**RE: Take 5 Oil – Snow Vista  
Grading Plan and Drainage Report  
Engineer’s Stamp Date: 11/03/23  
Hydrology File: M09D012C**

Based upon the information provided in your submittal received 11/06/2023, the Grading Plan and Drainage Report are approved for Building Permit, Grading Permit, and action by the Development Facilitation Team (DFT) on Site Plan for Building Permit. Please attach a copy of this approved plan in the construction sets for Building Permit processing along with a copy of this letter.

RE: Responses to Comments  
Dutch Bros Coffee  
1125 Snow Vista Boulevard S.W., Albuquerque, New Mexico 87121  
Our Job No. 23007

Job Number: **23007**  
Sheet: **C3.0**

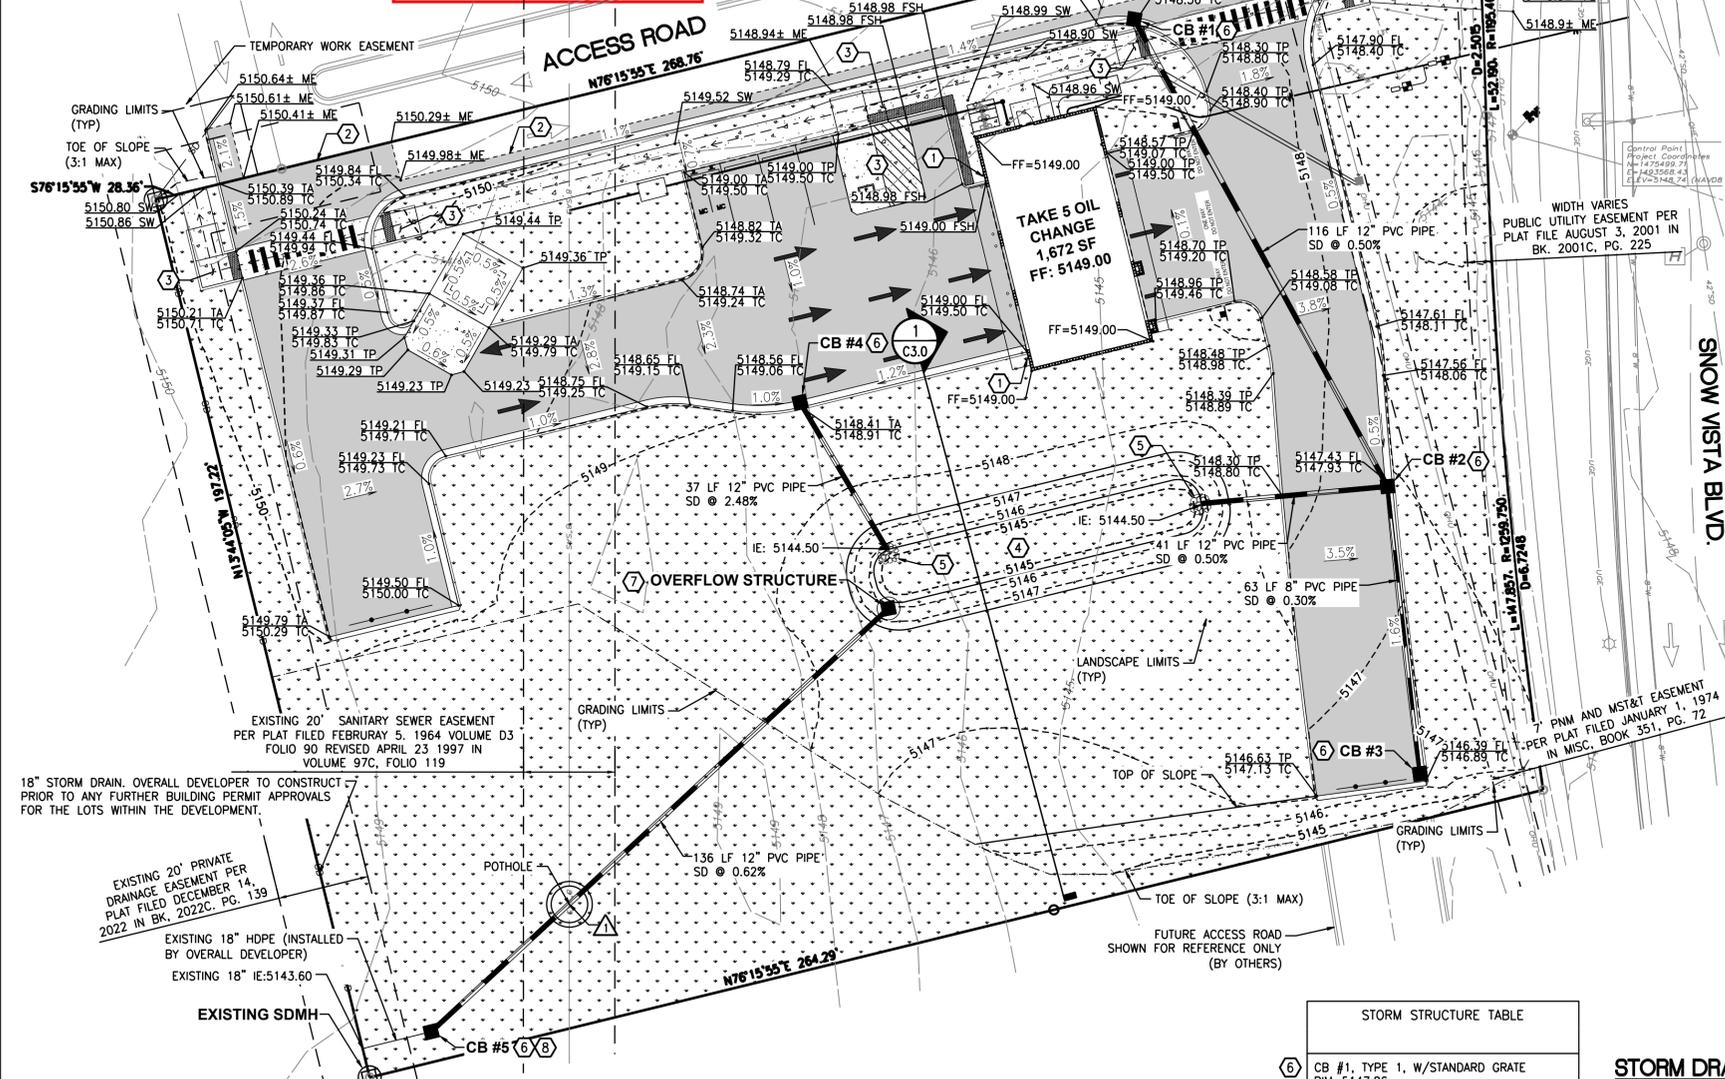
2. *Per the DPM, the following must be on the Grading Plan. Please note the Grading Plan must be a stand-alone construction document.*
  - a. *Please provide a Vicinity Map. Typically, this is the Zone Atlas. This can be downloaded in pdf format from the City of Albuquerque's website.*

3. *Please show the storm pipe that was approved for the overall development on July 20, 2023. Please label as "Overall Developer to construct prior to any further Building Permit approvals for the lots within the development." I have attached a pdf of the drawings for your use.*

6. *Please show the stub out that the overall developer is installing for this site based on the Master Drainage Plan. This stub out is for the outfall for this site. I have attached the Master Drainage Plan for your use.*

**Response:** The Vicinity Map has been added on Sheet C3.0.

**Response:** The storm pipe that was approved for overall development is shown.

**Response:** The stub-out is shown on the southwest corner of the site.

**FLOOD ZONE:**

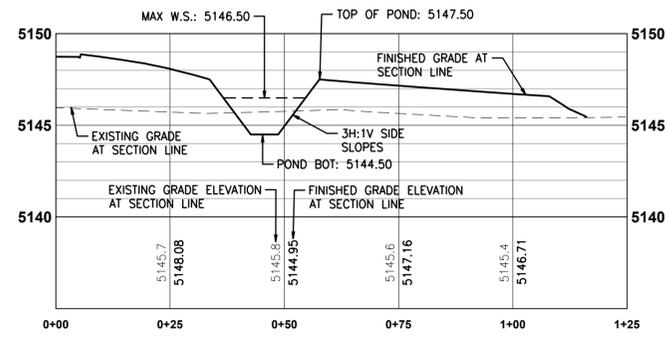
- b. *Please provide the full FIRM Map and flood plain note with effective date.*

**Response:** The full FIRM Map has been added with the effective date on Sheet C3.2.
